CHANGE REQUEST

⌘ **23.012 CR 015** ⌘ rev **2** ⌘ Current version: **5.2.0** ⌘

Title:	⌘ Addition of ADD feature		
Source:	⌘ Ericsson L.M., Telefonica		
Work item code:	⌘ TEI6	Date:	⌘ 02/03/2003
Category:	⌘ B	Release:	⌘ Rel-6
	<i>Use one of the following categories:</i> F (correction) A (corresponds to a correction in an earlier release) B (addition of feature), C (functional modification of feature) D (editorial modification) Detailed explanations of the above categories can be found in 3GPP TR 21.900 .		<i>Use one of the following releases:</i> 2 (GSM Phase 2) R96 (Release 1996) R97 (Release 1997) R98 (Release 1998) R99 (Release 1999) Rel-4 (Release 4) Rel-5 (Release 5) Rel-6 (Release 6)

Figure 4.1.2.1 (sheet 1 of 3): Process Update_Location_Area_VLR

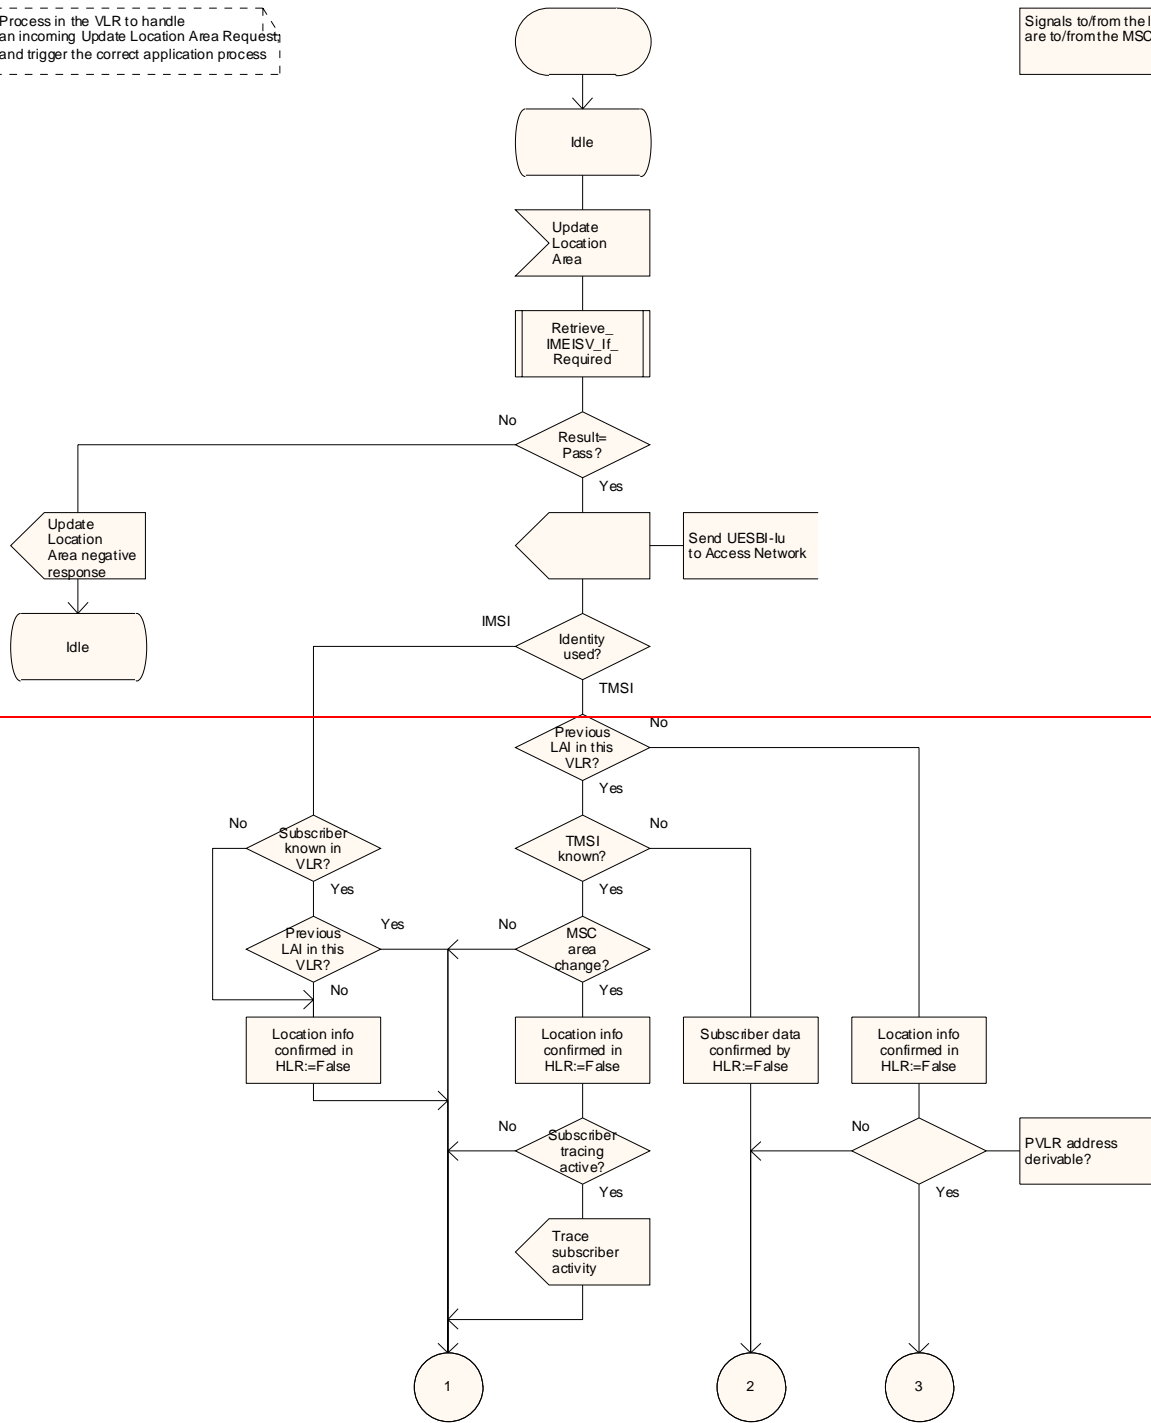
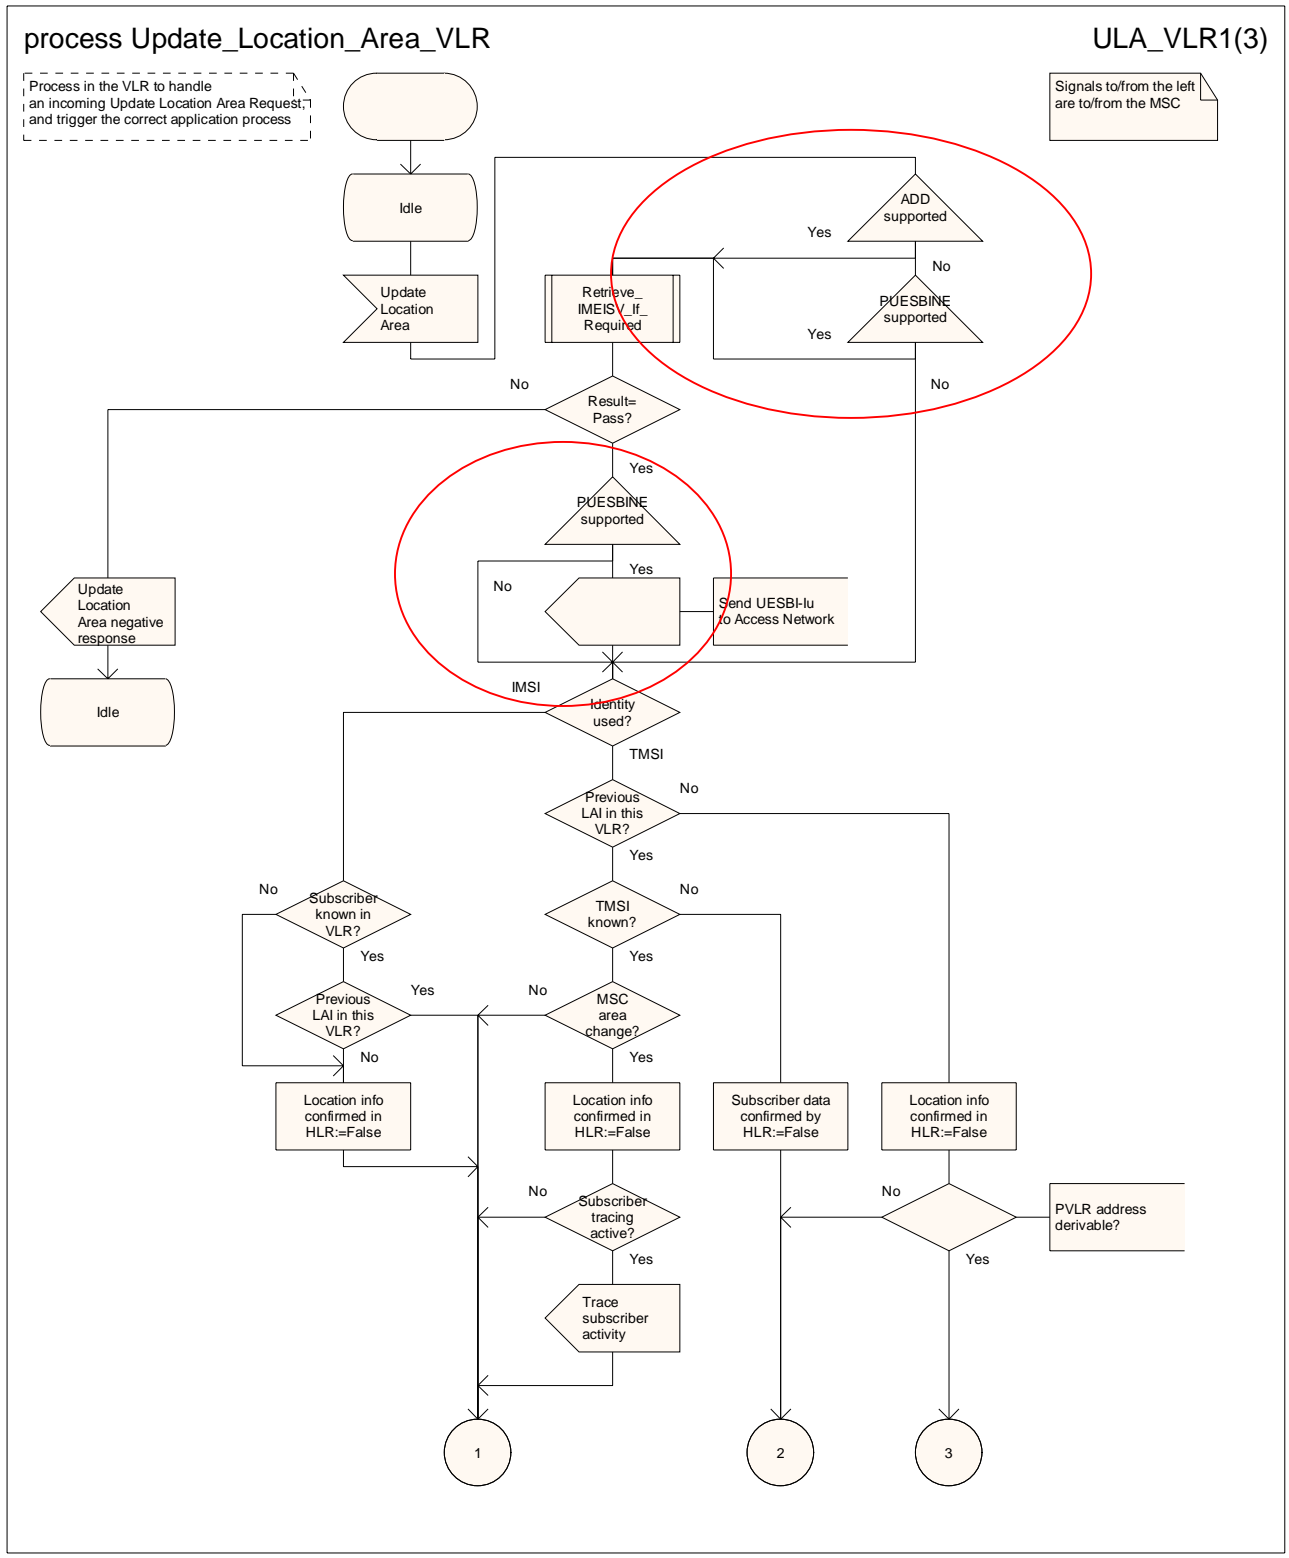
~~Sheet 1: the handling starting with the procedure call "Retrieve_IMEISV_If_required" and finishing with the output signal "Send_UESBI-Iu to Access Network" is specific to PUESBINE. If the VLR does not support PUESBINE, processing continues with the test "Identity used?".~~

The ADD function is an optional feature that allows the HLR to be updated with the current User Equipment (IMEISV) and thus enables the network to configure the subscriber's equipment based on a predefined profile. A device management system can retrieve the IMEISV either from VLR or from HLR, or be triggered by a changed IMEISV in either VLR or HLR. The mechanism for the configuration is outside the scope of this specification. The VLR requests the IMEISV and checks if the stored value is identical to the current one provided at the IMSI Attach/Location Update. If the IMEISV is not the same an Update Location message on MAP to the HLR is triggered including the IMEISV.

Figure 4.1.2.1 (sheet 2 of 3): Process Update_Location_Area_VLR

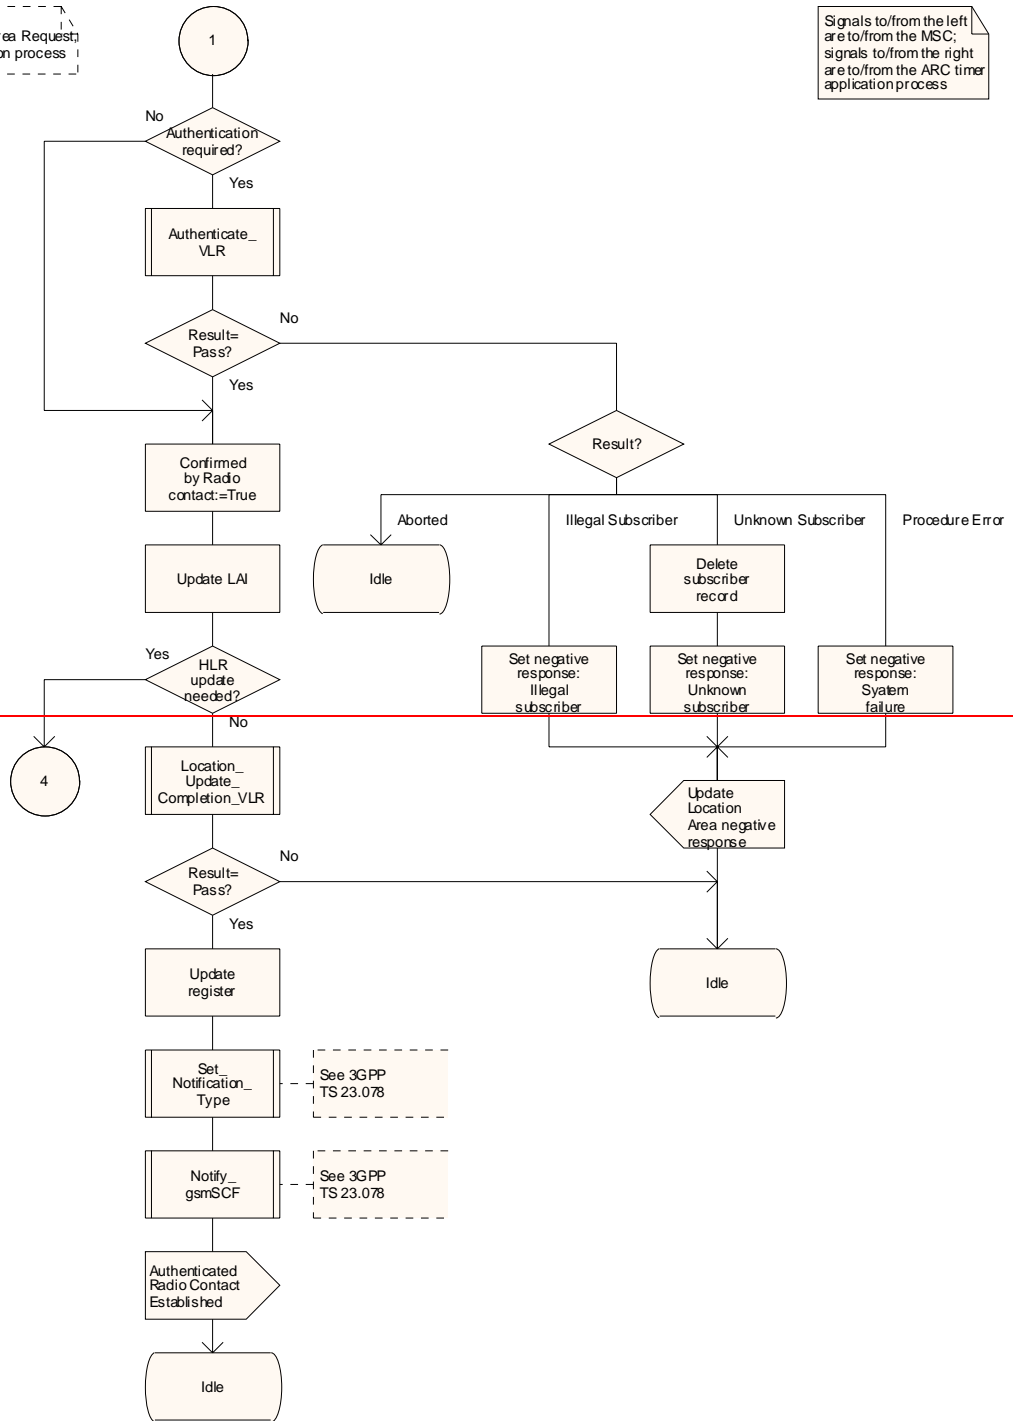
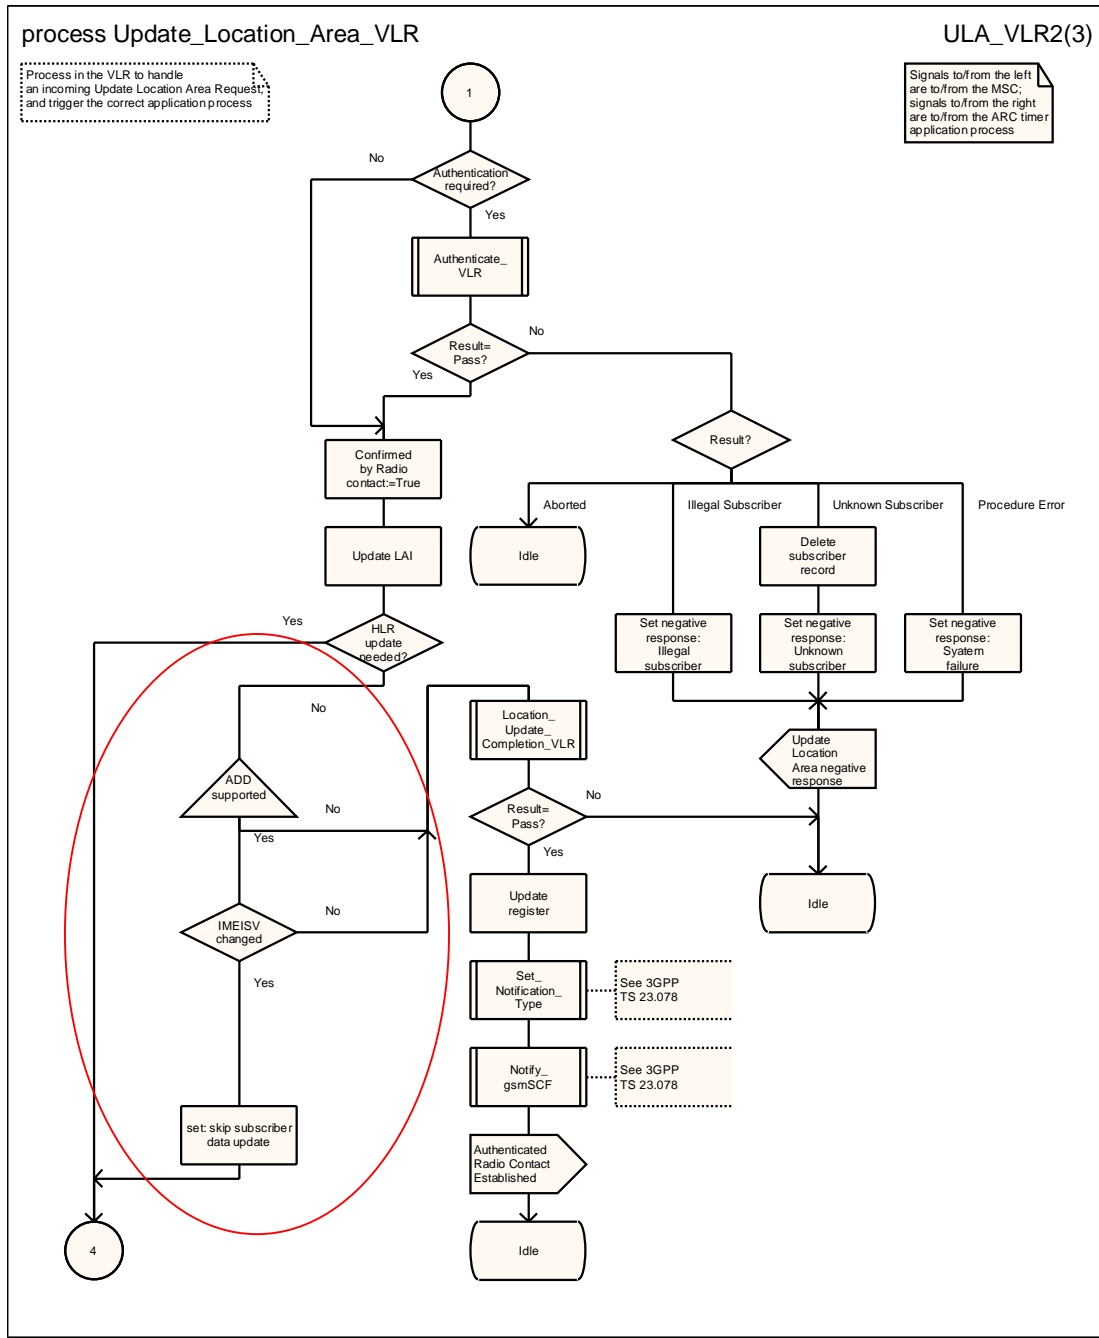
Sheet 2: at the decision "HLR updating required?" the "True" branch shall be taken if and only if one or more of the following conditions is true:

- (1) Location Info Confirmed in HLR is false.
- (2) Data Confirmed by HLR is false.

4.1.2.1a Procedure Retrieve_IMEISV_If_Required

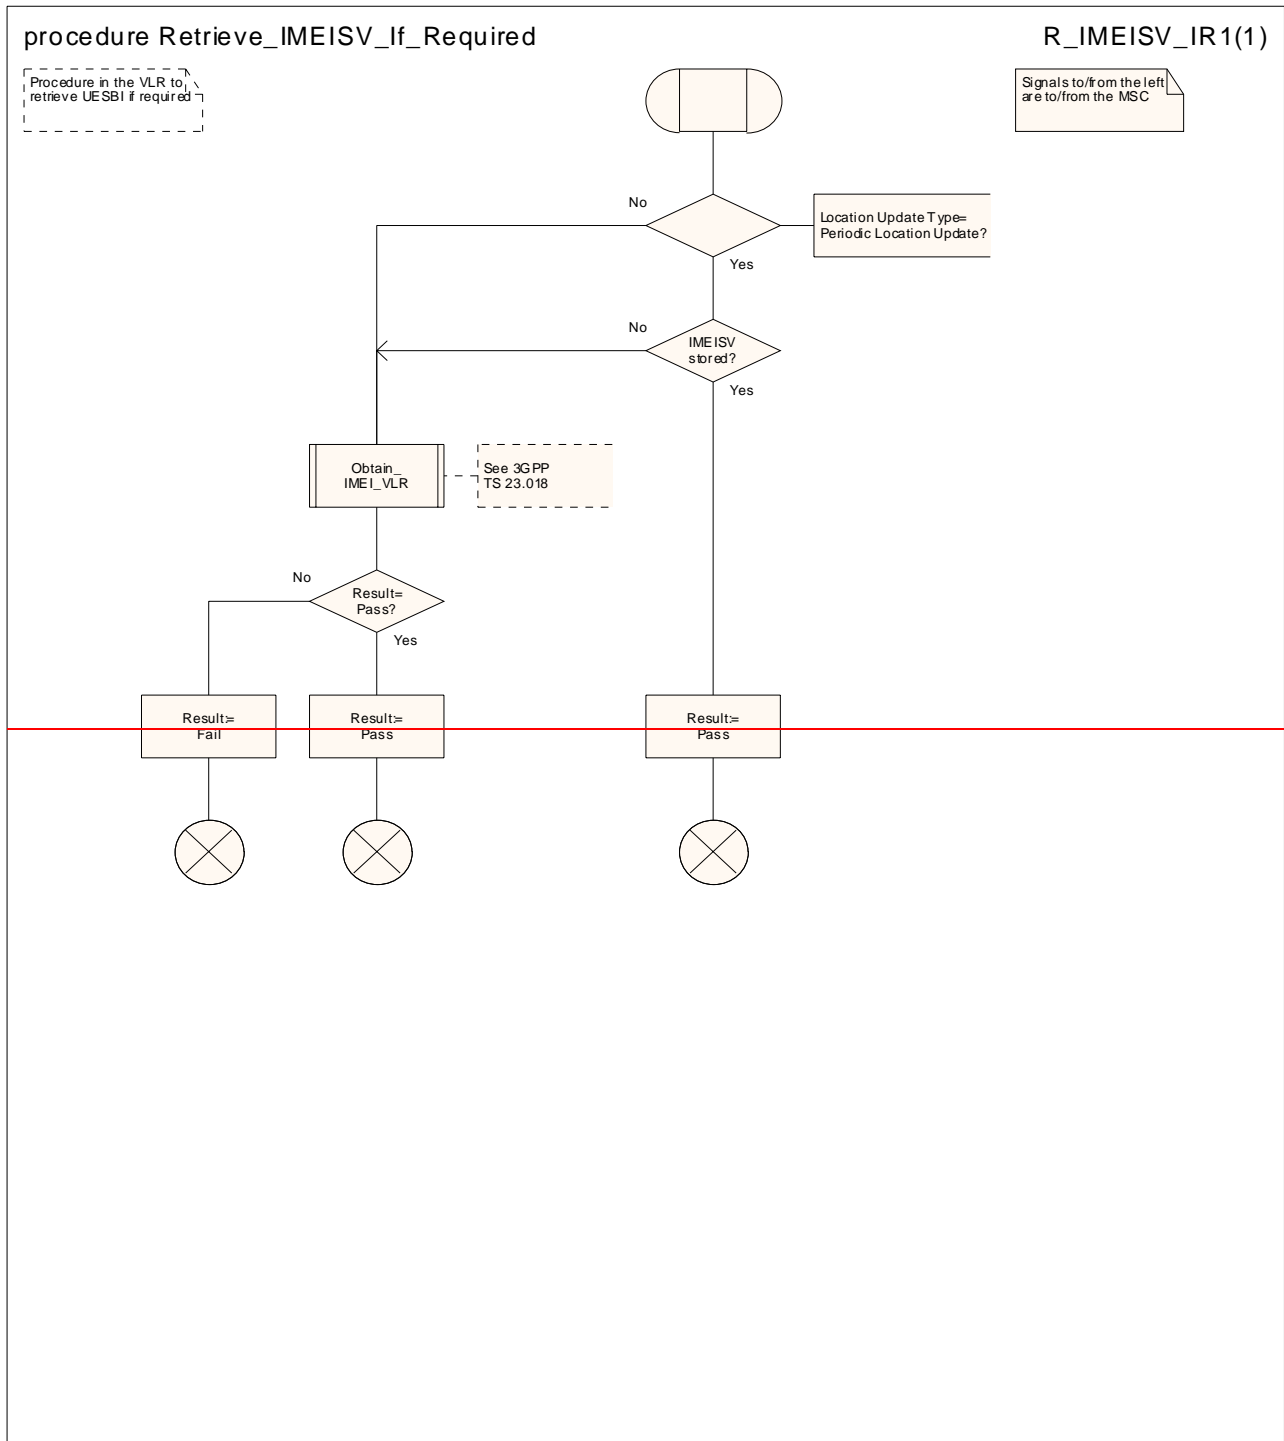
The decision box "received IMEISV = stored IMEISV" takes the "No" exit if no IMEISV is stored.

Figure 4.1.3.1 (sheet 1 of 3): Process Update_Location_HLR

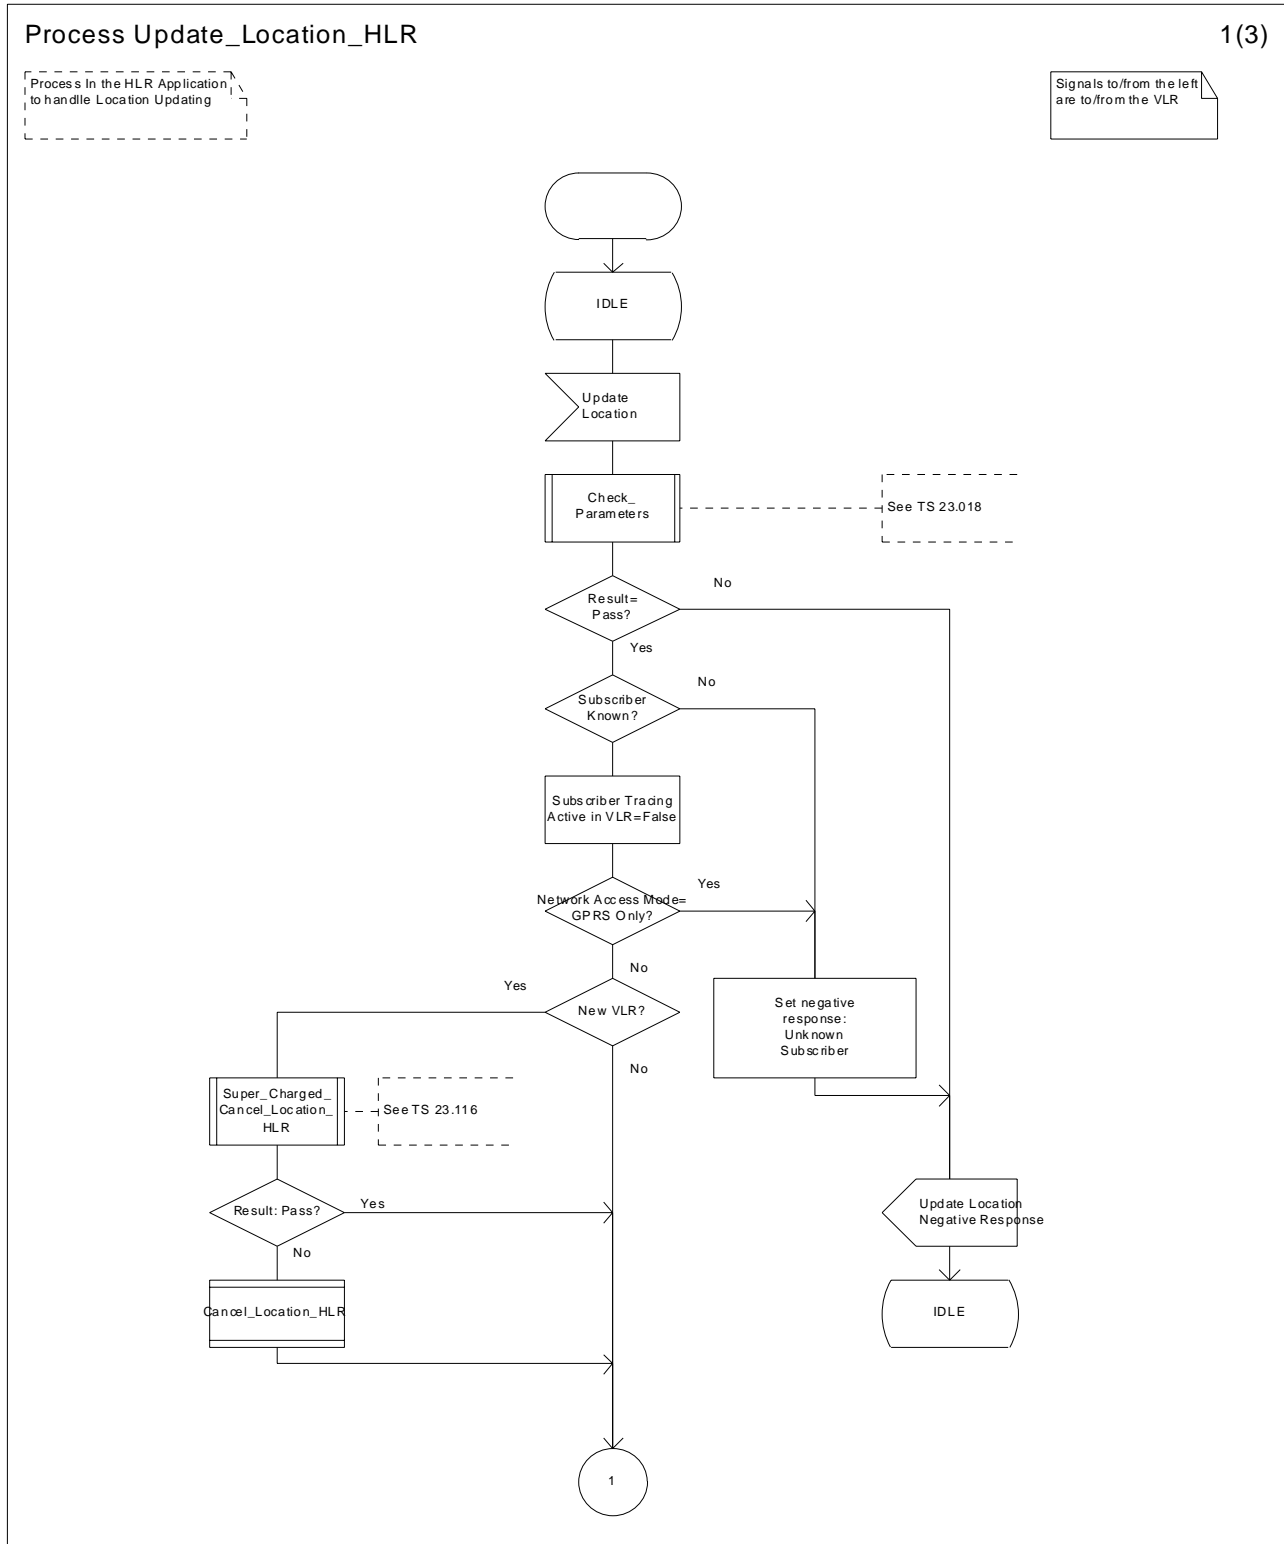
Sheet 1: The procedure Check_Parameters is specified in 3GPP TS 23.018 [5a].

Sheet 1: The procedure Super_Charged_Cancel_Location_HLR is specific to Super-Charger; it is specified in TS 23.116 [7]. If the previous VLR and the originating HLR support the Super-Charger functionality, processing continues from the "Yes" exit of the test "Result=Pass?".
